Superior  
National  
Forest

Date: July 27, 2011

## **USDA Forest Service Technical Comments on the Regional Haze State Implementation Plan (RH SIP) for Wisconsin**

## Tracking Progress 2000-2004 to 2005-2009

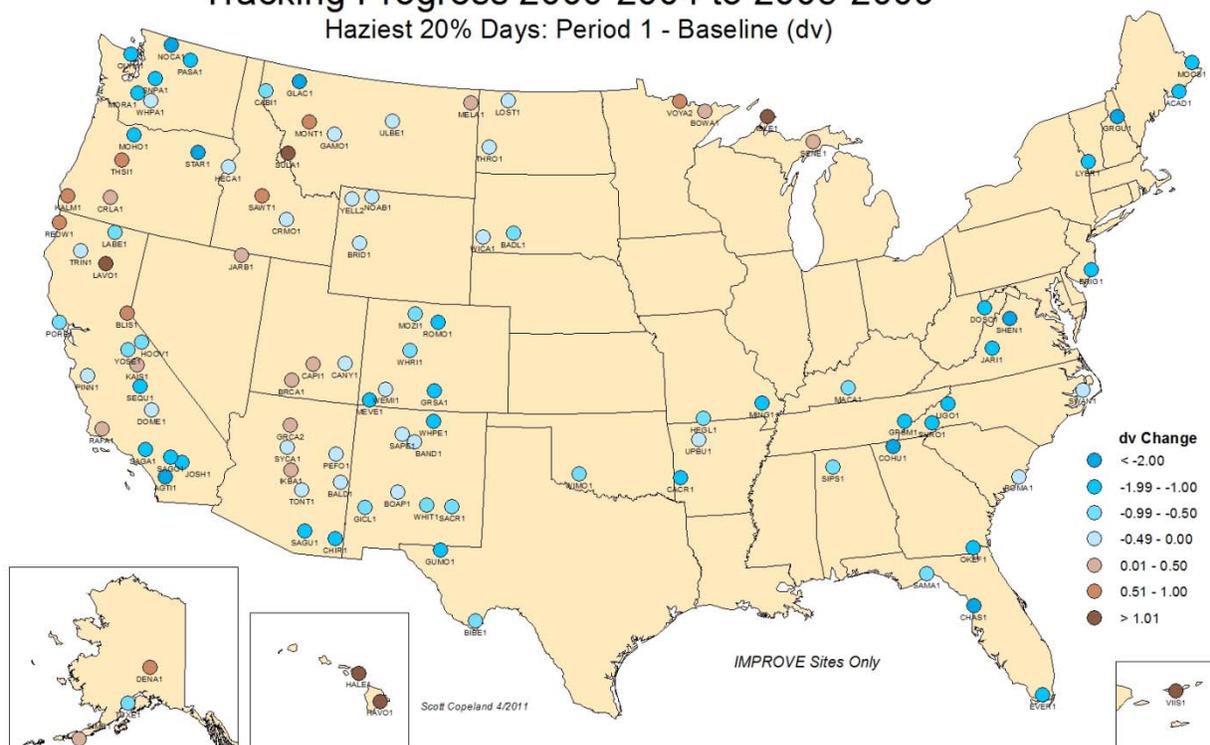
8. Analysis of recent visibility data shows that in the eastern US only the Northern Class I Areas have degraded since the baseline period (see figure below from upcoming IMPROVE Report). This means the amount of work to achieve the RPGs has increased. Please note this in the SIP.
